STAFF REPORT: 9/11/2024 MEETING

ADDRESS: 7873 VAN DYKE PLACE

APPLICATION NO: #HDC-2024-00471

SCOPE: REHABILITATE DWELLING, ERECT GARAGE

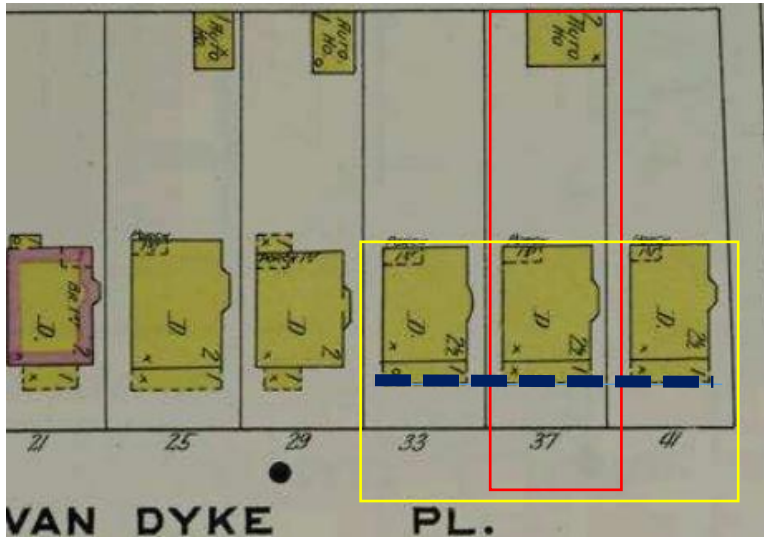
***Please note that the current site plan drawing **is not accurate/does not conform to the building's elevation and plan drawings** (sheets A1.3, A2.2, A2.3), as it depicts a front façade porch which wraps around the building's west façade. The applicant has stated that he wishes the Commission to review the front porch and side deck design **as depicted in the building plan and elevation drawings** (sheets A1.3, A2.2, A2.3) sent to staff on 9/6/2024 as a revision to the original submission/posted documents, which proposes a full width, one-story hipped roof porch on the front façade and a separate small porch deck at the west wall's entrance.

- The applicant shall revise the site plan drawing so that it aligns with the building's elevation and plan drawings
- If the new side deck shall be constructed of wood per the submitted drawings, it shall have a subtle emphasis in its detailing that clearly distinguishes it as a deck, and not as a "roofless" porch. The applicant shall submit the final design of the new side deck to staff for review and approval prior to the issuance of the project's permit.
